Access Compliance Report

Public Rights-of-Way

(Pedestrian Signals)

Intersection ID: N/A	Main Street:	Cross Street: N/A	Location: N/A
ADA ID: 7D2BA2A6C9A6	Signal Type: Two Push Buttons-Non APS	Overall Compliance: No	Severity Score: BTN 1:N/A BTN 2: N/A No BTN: N/A
Codes/Mitigation Info/Possible Solution		Field Measurements/Component Compliance

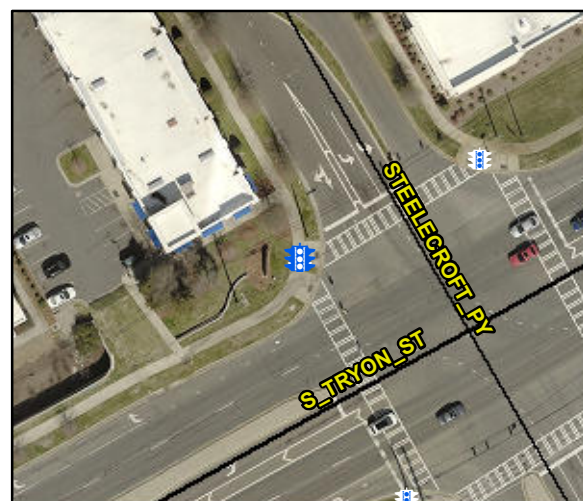
PROW/ADA: TMUTCD 4e.08, R404.2, R406.2, R404.7.3

Yes	B 1 Clear Xing Direction?	ClearlyMarked	Yes	B 2 Clear Xing Direction?	ClearlyMarked
	B 1 Crossing Direction	To SE		B 2 Crossing Direction	To NE
Yes	B 1 DistanceTo XWalk (in)	0.0	Yes	B 2 DistanceTo XWalk (in)	0.0
No	B 1 DistanceTo Curb (in)	95.0	No	B 2 DistanceTo Curb (in)	94.0
Yes	B 1 Diameter (in)	2.0	Yes	B 2 Diameter (in)	2.0

Possible Solutions: Replace Signal Push Button With APS Button on New Post. Remove & Relocate Sign.
